# Update September 17, 2020

#### CONDITION OF CONCERN

OUTLINE OF REPAIR - Temporarily starting September 18 replace Front Cross Member due to expiration of Cavity Wax and install drain hose.

# PARTS AND WARRANTY INFORMATION Recall Campaign 2818I

Drain hose

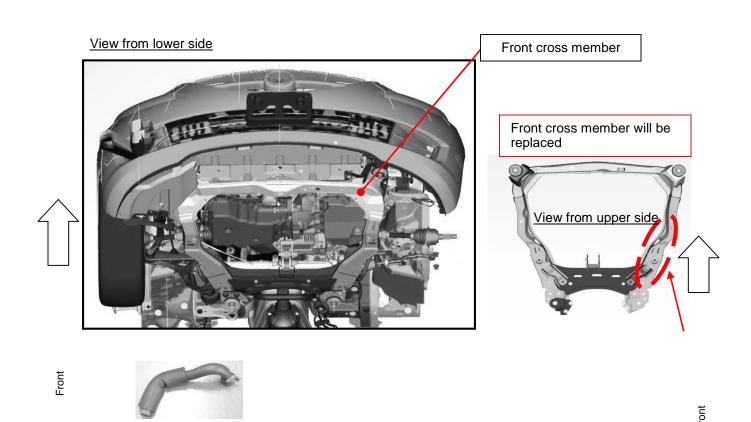
On certain subject Mazda6 vehicles in salt belt states, it is possible the front cross member may be corroded due to suspected insufficient paint coating. Continued use of the vehicle may allow the corrosion to progress, causing the support of the right lower control arm to decrease. Passing over a pothole may result in breakage of the cross member and reduced steering control, increasing the risk of a crash.
